# Access Compliance Report

## Public Rights-of-Way

Intersection ID: 16769	Main Street: KELLY_ST	Cross Street: SUMMEY_AV	Location: NW
ADA ID: 9C0895F0D1EA	Ramp Type: BlendTrans1	Initial Pass/Fail: Fail	Overall Compliance: No
		Severity Score: 42.5

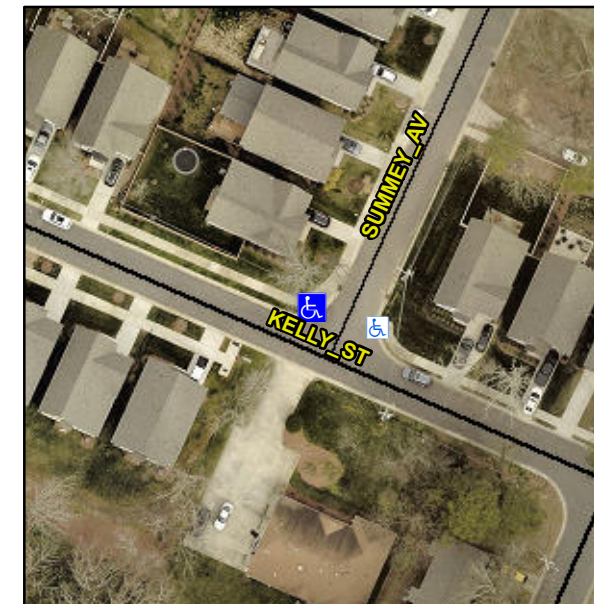
**Not Found, R304.5.1, R304.5.3**

Compliance	Description	Data	Compliance	Description	Data
N/A	Ramp Length (in)	49.0	Yes	BlendTrans Slope (%)	3.5
No	Ramp Width (in)	34.0	No	BlendTrans XSlope (%)	7.6
N/A	Flare Type LT	N/A	N/A	Flare Type RT	N/A
N/A	Flare Slope LT (%)	N/A	N/A	Flare Slope RT (%)	N/A
N/A	Flare Traversable LT?	N/A	N/A	Flare Traversable RT?	N/A
N/A	Landing Length (in)	N/A	N/A	DWS Provided?	N/A
N/A	Landing Width (in)	N/A	N/A	DWS Contrast?	N/A
N/A	Landing Slope (%)	N/A	N/A	DWS Length (in)	N/A
N/A	Landing X Slope (%)	N/A	N/A	DWS Full Width?	N/A
N/A	Landing Curb? (Y/N)	N/A	N/A	DWS Offset (in)	N/A
N/A	Shared Landing?	N/A			
N/A	Gutter Ponding?	N/A	N/A	Gutter Slope (%)	N/A
N/A	Gutter Lip Ht (in)	N/A	N/A	Gutter X Slope (%)	N/A
N/A	Painted X Walk1?	No	N/A	Painted X Walk2?	N/A
	X Walk 1 Direction	To SE		X Walk 2 Direction	N/A
	X Walk 1 Width (in)	N/A		X Walk 2 Width (in)	N/A
	X Walk 1 Slope (%)	6.7		X Walk 2 Slope (%)	N/A
	X Walk 1 X Slope (%)	2.2		X Walk 2 X Slope (%)	N/A

**Remove & Replace Curb Ramp With Two New Directional Ramps or Equivalent.**
